TYPE II LAND DIVISION STAFF REPORT & DECISION

50th AVENUE INFILL SHORT PLAT

PLD2009-00047; EVR2009-00044

Copy of Revised Preliminary Plan – Exhibit 19

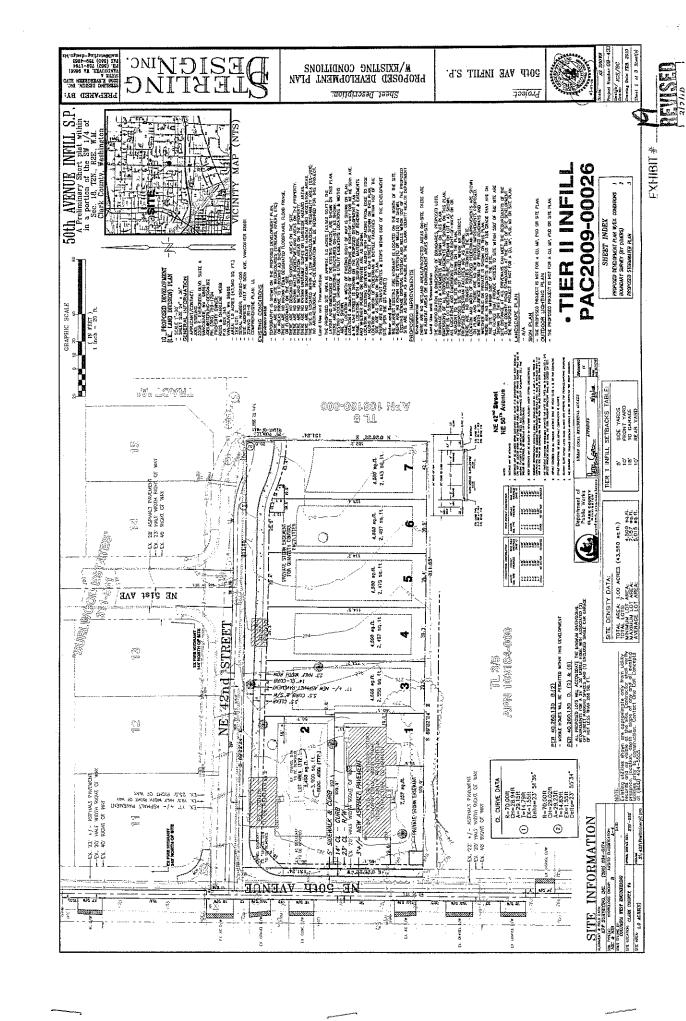
The revised plan [Exhibit 19] shows building envelopes for the remaining parcels. The envelope on Lot 3 does not correctly reflect the side setback along the west property line of this parcel. This situation shall be corrected on the final plat (See Condition D-1).

Maximum lot coverage by buildings constructed on individual lots may be sixty (60) percent. The revised preliminary plan [Exhibit 19] identifies building envelopes that, if fully encumbered with structures, will exceed this standard. To ensure compliance with this code provision, a plat note to this effect will be required (See Condition D-9-c).

- **D-1** <u>Building Envelope</u>: The building envelope on Lot 3 shall be revised to correctly reflect how the 5-foot side setback along the west property line is measured. (See Land Use Finding 4)

- **D-9** Plat Notes The following notes shall be placed on the final plat:
 - a. <u>Lot Coverage</u>: Lot coverage by all buildings constructed on individual lots shall not exceed sixty (60) percent. (See Land Use Finding 4)
